CITY PLAN COMMISSION STAFF REPORT

Villa Meadows 2nd Plat

- 3.1 CD-CPC-2022-00046 – Rezoning
3.2 CD-CPC-2021-00247 – Revised Preliminary Plat

PRELIMINARY PLAT AMENDMENT
VILLA MEADOWS SECOND PLAT
for DISTRICT R-7.5 & R-80
South Half Sec. 22, Twp 48, Rge 32
Kansas City, Jackson County, Missouri

PRELIMINARY PLAT
VILLA MEADOWS SECOND PLAT
SECTION 22, TOWNSHIP 48, RANGE 32
KANSAS CITY, JACKSON COUNTY, MISSOURI

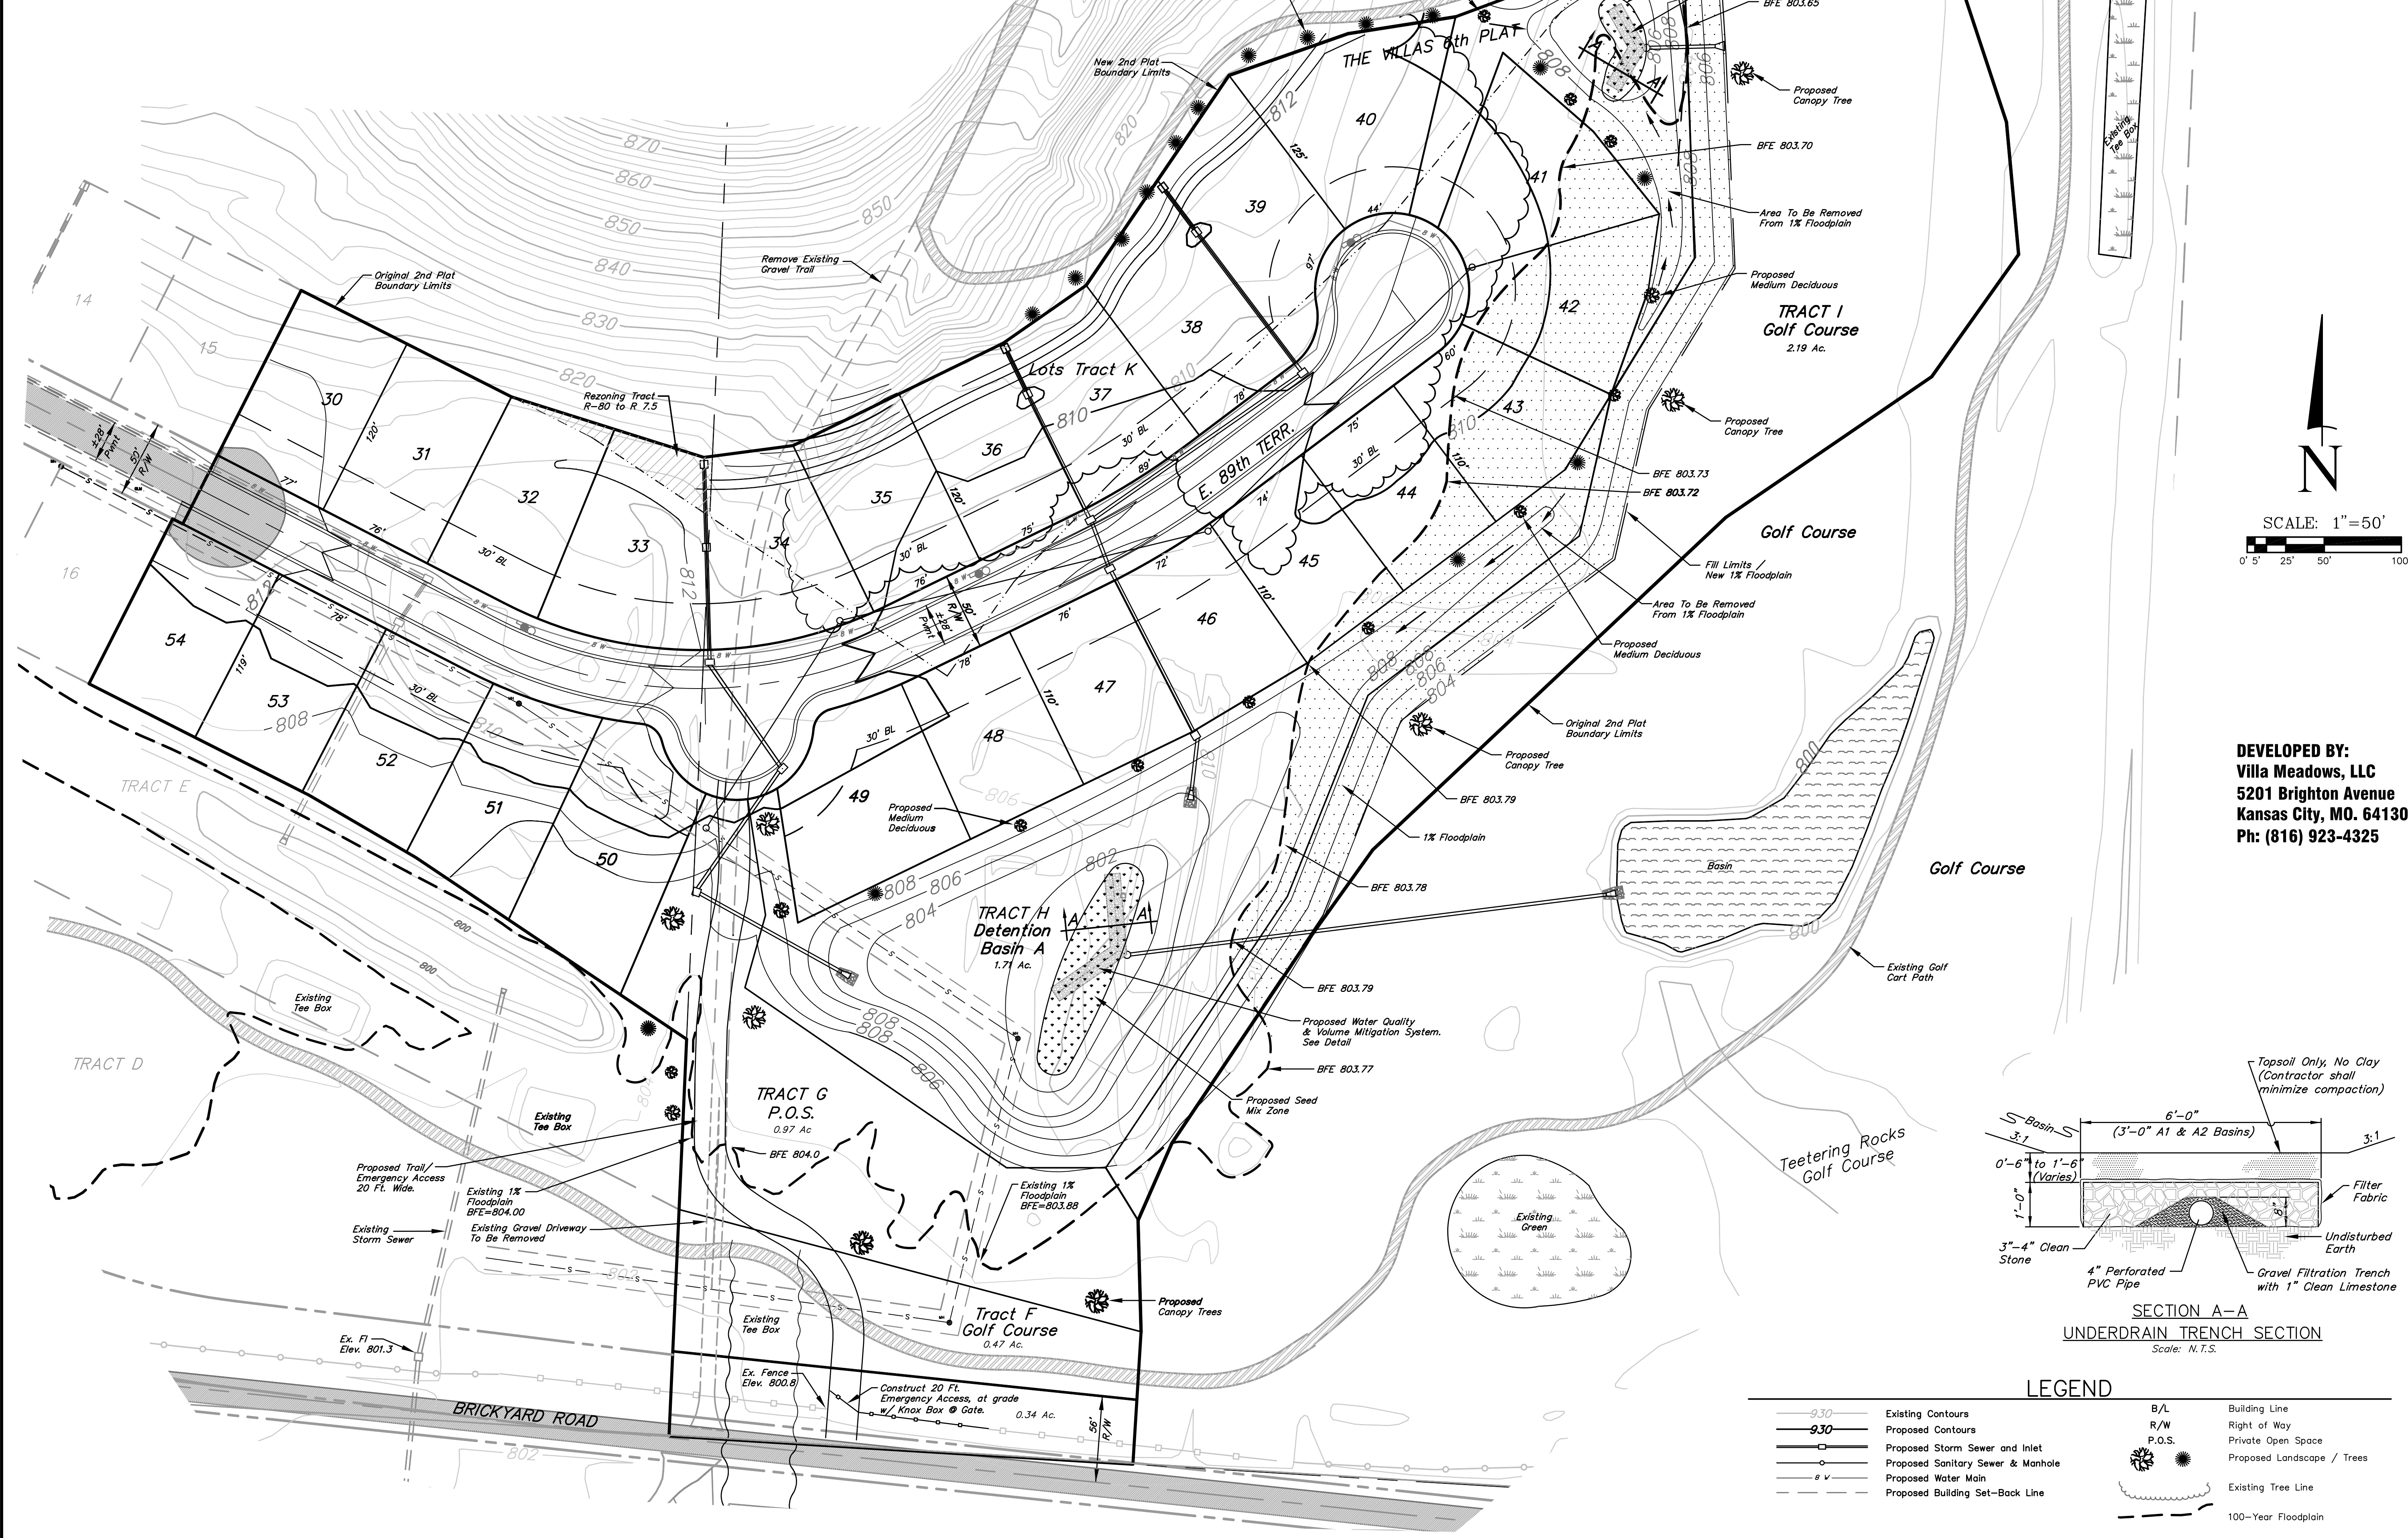
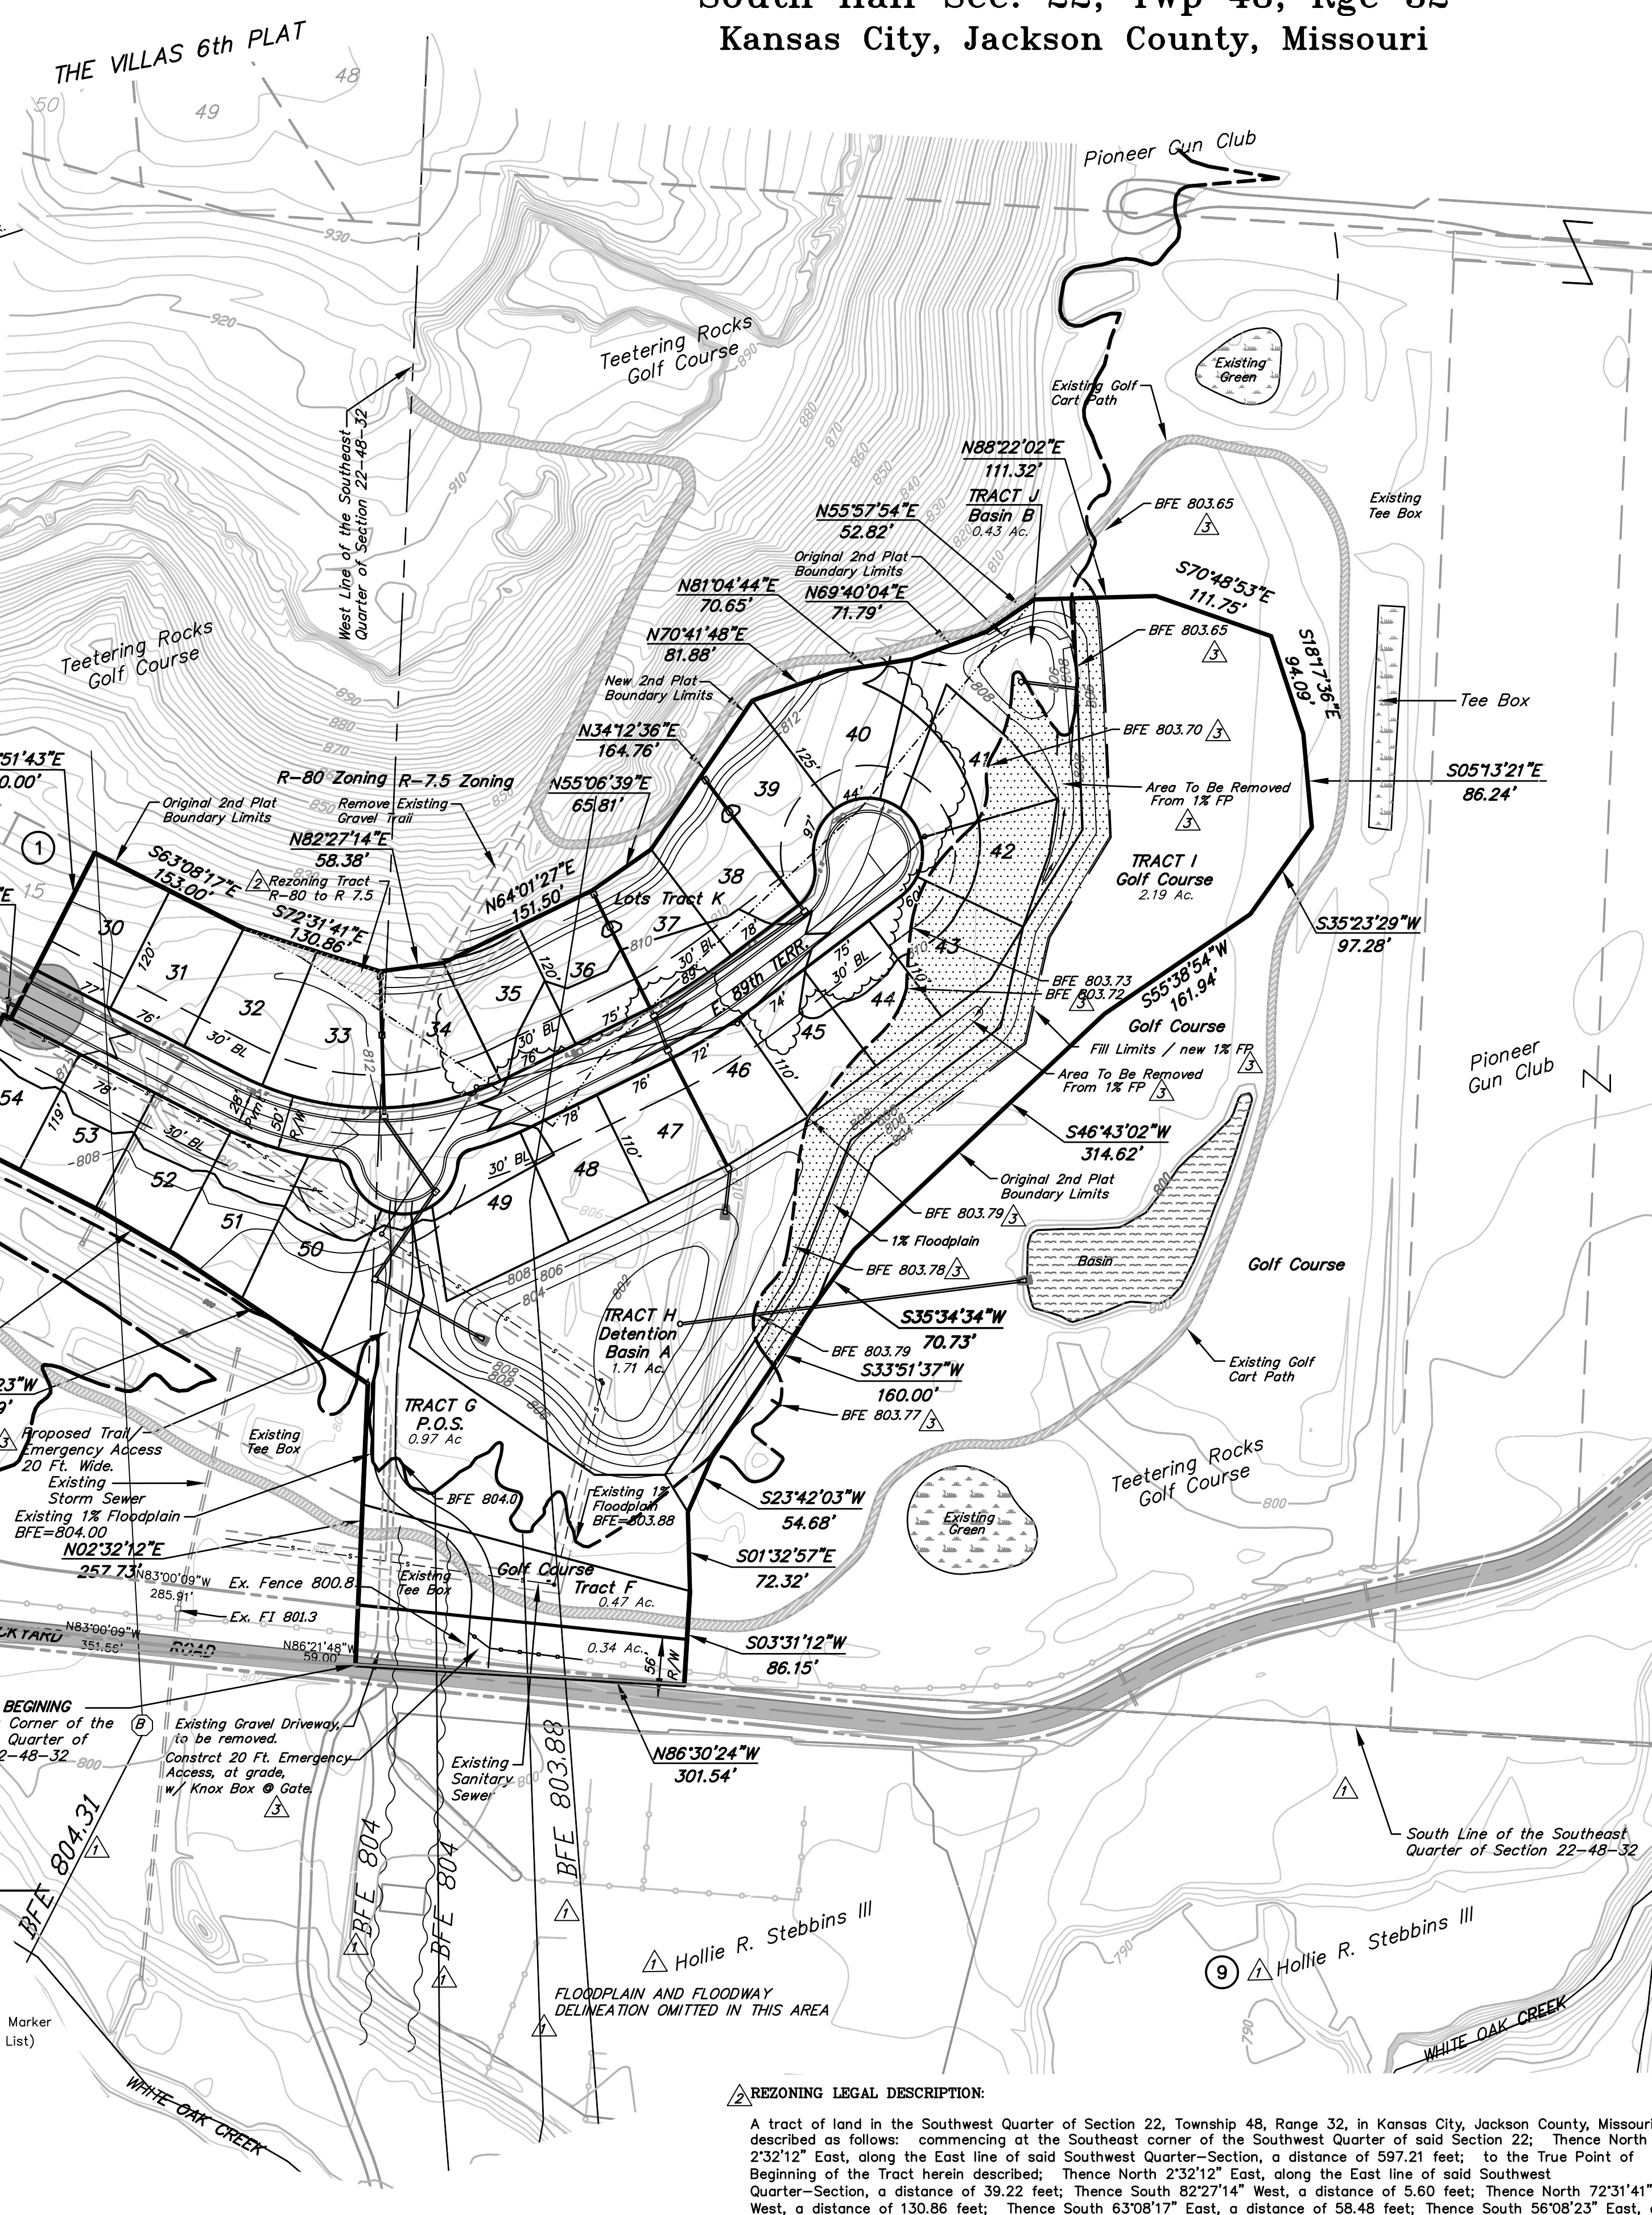
The proposed water mains must be designed and constructed with a minimum of 10' of horizontal separation to existing and proposed parallel water and sewer mains. (Lots 30,31,37,38)
